## RC220255 (CODC) AND RM220834 (QLDC) – HEARING PANEL QUESTIONS TO THE QL HARBOURMASTER

1. The applications for RC220255 (CODC) and RM220834 (QLDC) provide the following detail regarding the anchor/mooring system for the dredge operation:

**Attachment 1**

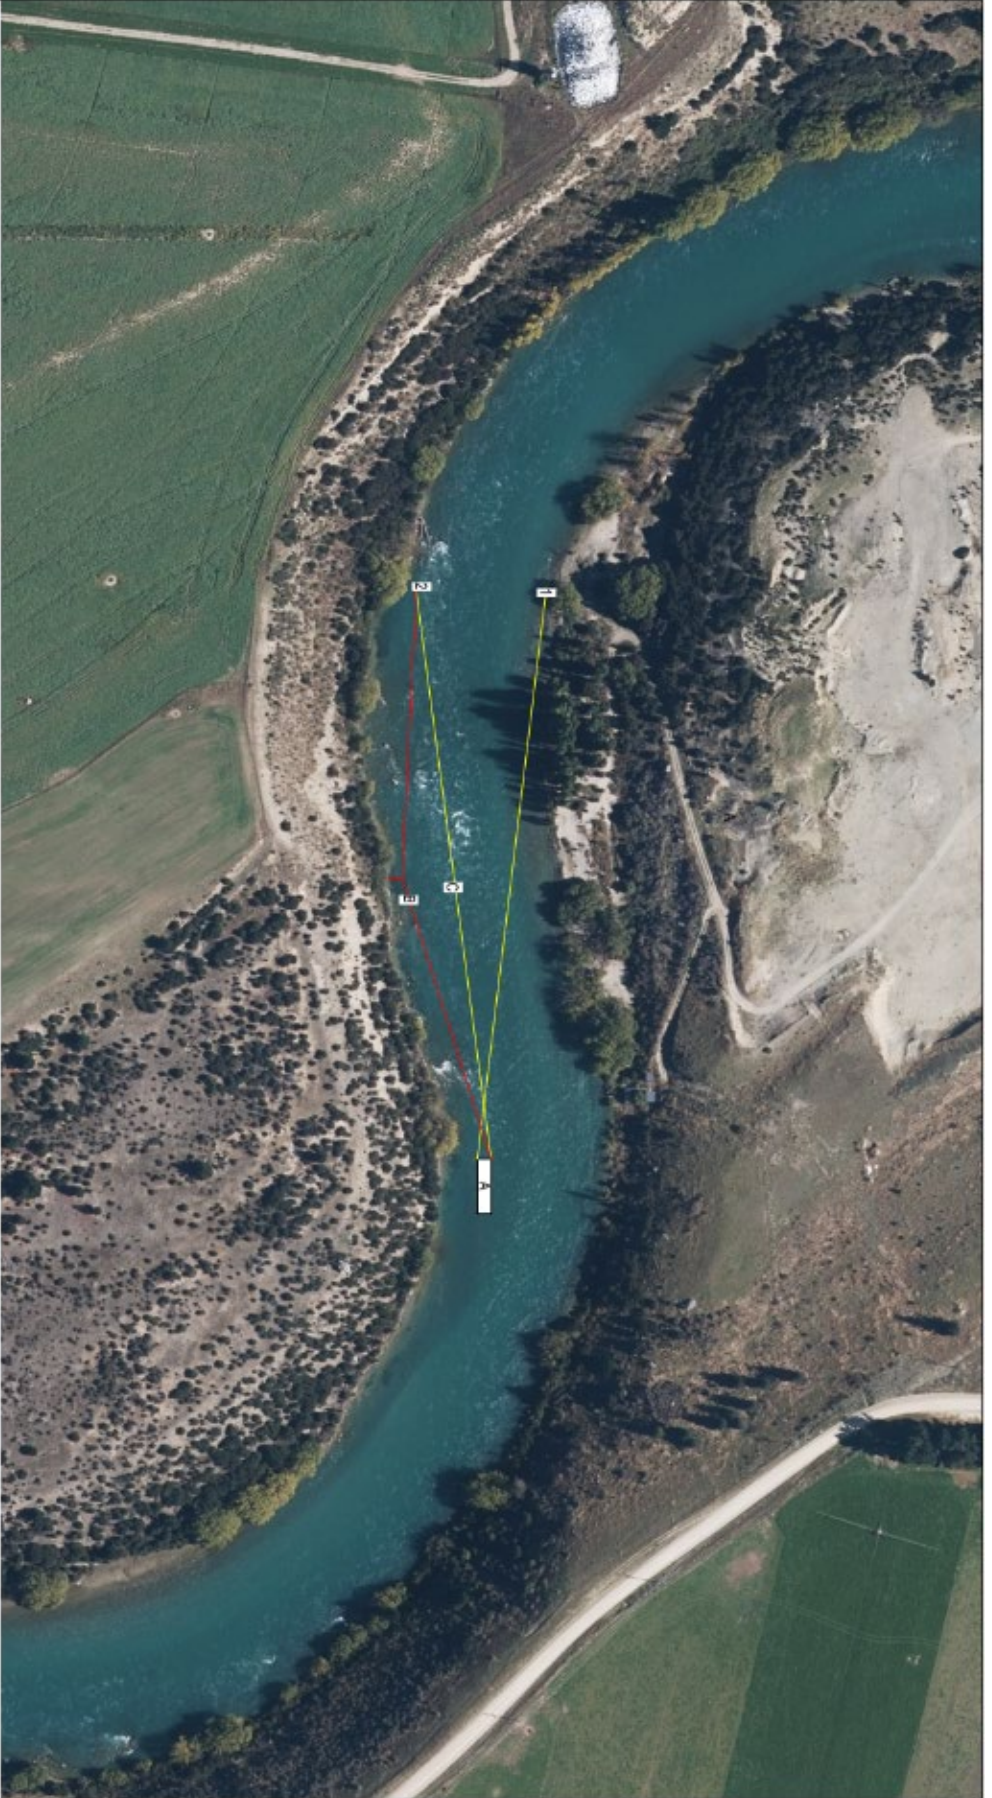
The diagrams at Attachment 1 shows the anchoring system for the dredge in two scenarios depending on the form of the river.

**Question: Do the diagrams at Attachment 1 reflect your understanding of the anchoring/mooring system as described in the AEE when you reviewed the applications in June 2023? NO. As above the original application indicated that the anchoroes would be directly in front of the dredge and not protrude out into the river flow.**
